Powerhead Water Ingestion - 225 Model

Mariner and Mercury

1994 and 1995
225 hp Models
S/N 0D280813 thru 0G178947

Figure 1. New Exhaust Adaptor Plate.

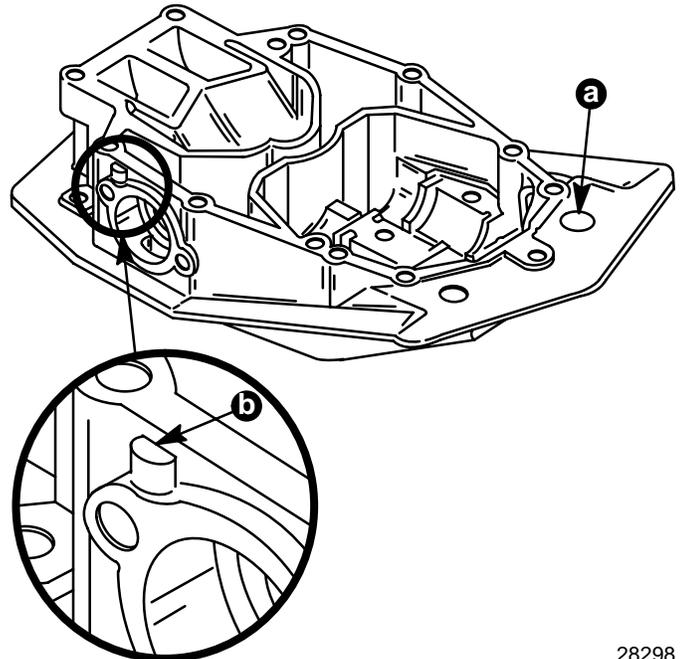
Some outboards within this serial number range were modified at the factory. Factory modifications and some early field modifications have the new exhaust adaptor plate p/n 818450A-1 installed. The new adaptor plate is identified with a raised boss above the poppet valve opening and p/n 818450C-2 is cast in the front of the plate as shown in figure 1.

a - Casting Number 818450C-2
b - Raised Boss

Figure 2. Cylinder Inspection.

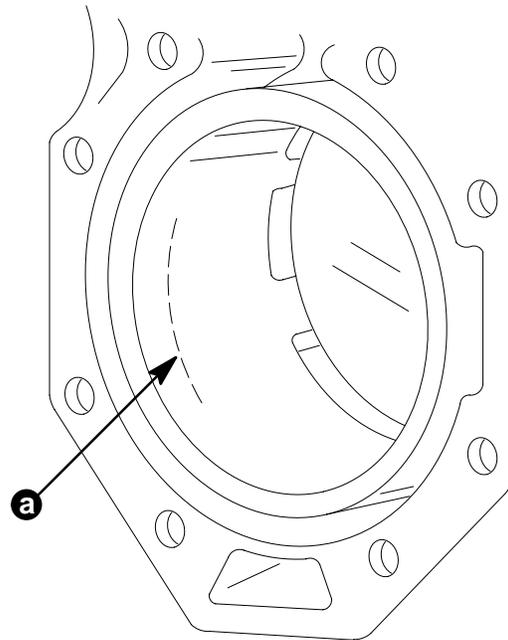
1. Remove both cylinder heads.
2. Clean bores with Quicksilver Paint Leveler p/n
92-75996.
3. Inspect cylinder bores for cross hatch pattern, pit-
ting and wear. Figure 2 shows piston ring travel
limit.

Acceptable:

- Corrosion/discoloration above ring travel area
- Non-Uniform honing cross hatch
- Minor scratches

Unacceptable:

- Heavy corrosion or pitting in ring travel area.
- Honing cross hatch worn away.
- Scored Cylinder - deep vertical marks.

a - Limit of Ring Travel.

Figure 3. Drilling Fixture.

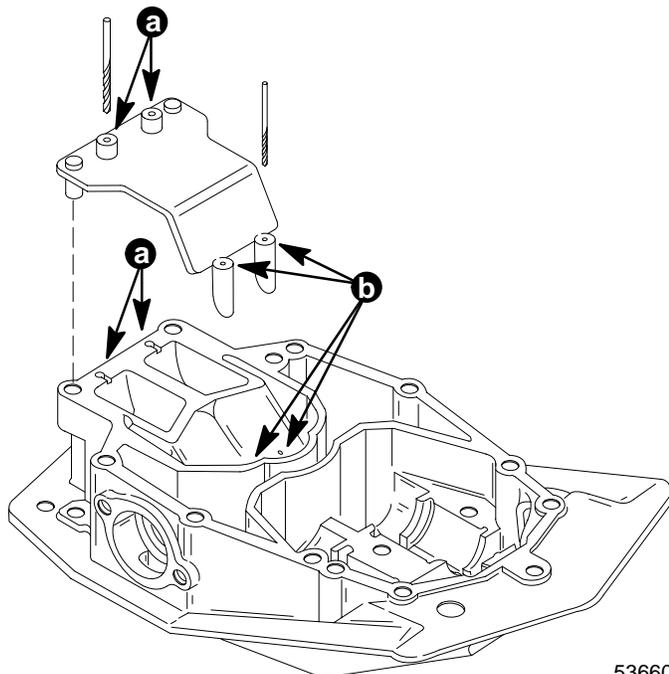
1. Remove powerhead per Service Manual 90-822900 page 4A-7 thru 4A-10.
2. Clean gasket material from powerhead base flange and exhaust adapter plate surface.
3. Clean any corrosion from the powerhead base flange using a small diameter wire wheel on an electric or air tool. Use care not to damage or round-off the gasket surfaces.
4. Paint the powerhead base flange with cold-galvanizing or zinc-rich paint, such as Rust-oleum ZINC-SELE 7785 to prevent corrosion. Apply two light, uniform coats and allow to dry 30 minutes for each coat. Outboards after s/n 0G178948 have a protective coating on the gasket surface.
5. Assemble drill fixture 828809 to the exhaust adapter plate and drill four holes per figure 3.

- a - 3/16 inch (4.8 mm) Diameter Holes 1/8 inch (3.2 mm) Deep.
- b - #39 Drill (2.6 mm) Hole Completely Through Casting Section.

Figure 4. Plug installation.

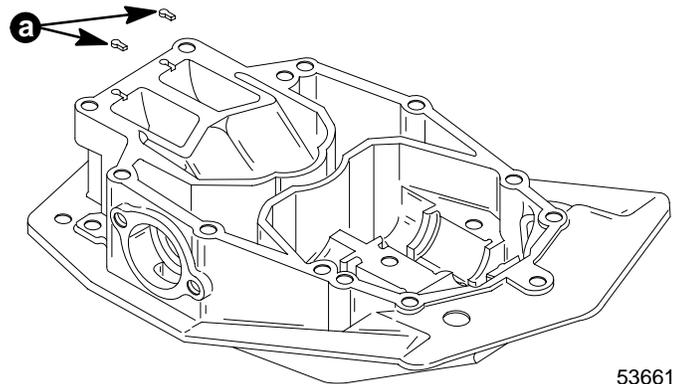
6. Install two p/n 19-828808 plugs into the exhaust adapter plate as shown in figure 4. The top of the plugs must be flush with the gasket surface. It is not necessary to Loctite or seal the plugs in place.

- a - Plugs (2).

Figure 5. Water Drain Check Valves.

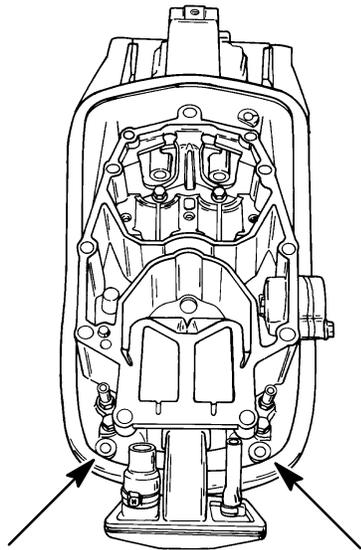
1. Remove the two 2-1/4 inch (57 mm) long water drain check valves from the exhaust adaptor plate as shown in Figure 5.

2. Install new 3-1/2 inch (89 mm) long drain check valves p/n 21-817519A-1 by pushing them securely into the exhaust adaptor plate. Outboards after s/n 0G147354 have the longer drain check valves installed.

Figure 6. Engine Harness Connector.

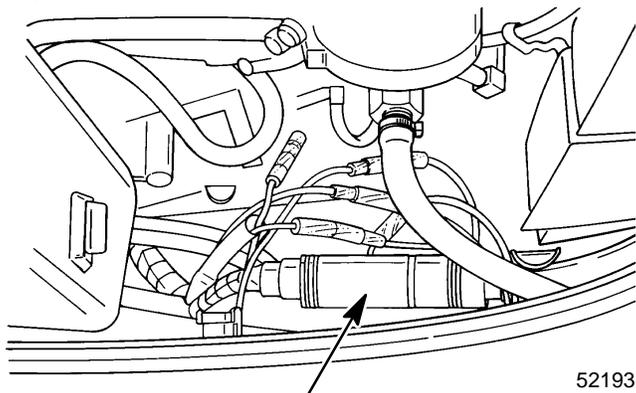
Inspect, clean, and apply dielectric grease p/n 92-823506--1 to the engine harness connector pins. The engine harness connector located on the starboard side of the engine, lays in the lower cowl on 1994 models and requires extra protection.

Figure 7. Top Cowl Bottom View.

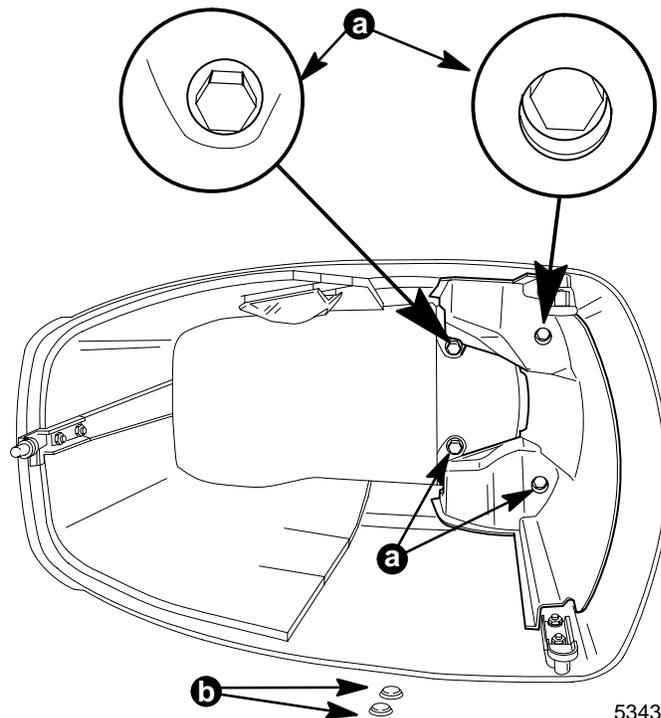
1. Remove the top cowl rear air inlet cap by removing the two hole plugs and the four rear cap attaching screws on the inside of the top cowl per figure 7.

a - Attaching Screws.
b - Hole Plugs.

Figure 8. Cowl air Inlet Holes

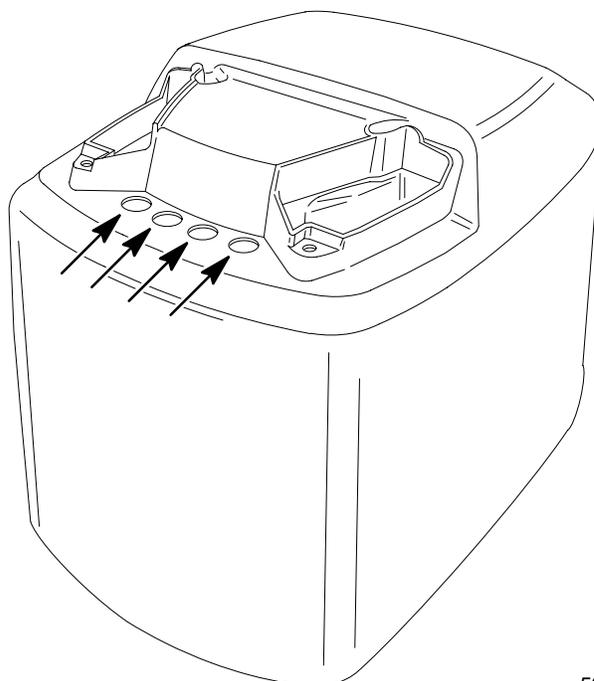
2. Apply duct tape or masking tape on the top cowl painted surface to be drilled.
3. Align the cowl drilling template and mark the four hole center locations.
4. Drill four 1 inch (25.4 mm) diameter holes from the outside through the cowl per figure 8. Care must be taken not to allow the hole drill to contact the air deflector on the inside of the top cowl.
